PCI-SIG ENGINEERING CHANGE REQUEST

TITLE:	OCuLink BP Type ECR
DATE:	May 19, 2017
AFFECTED DOCUMENT:	OCuLink Specification version 1.0
SPONSOR:	Jay Neer (Molex), Alex Haser (Molex)

Figure 2-x. Upstream/ Downstream Port Assignment

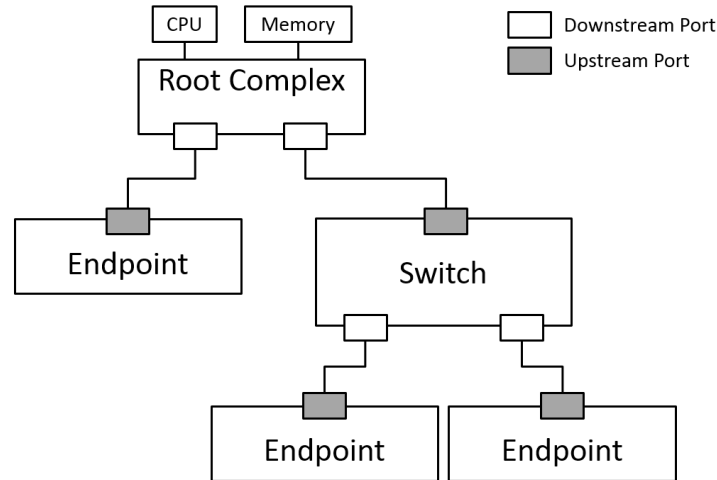
Upstream/ Downstream port assignment is defined as shown in Figure 2-x below. This naming convention is consistent across all PCI Express documentation. Refer to the *PCI Express Base Specification* for more information.
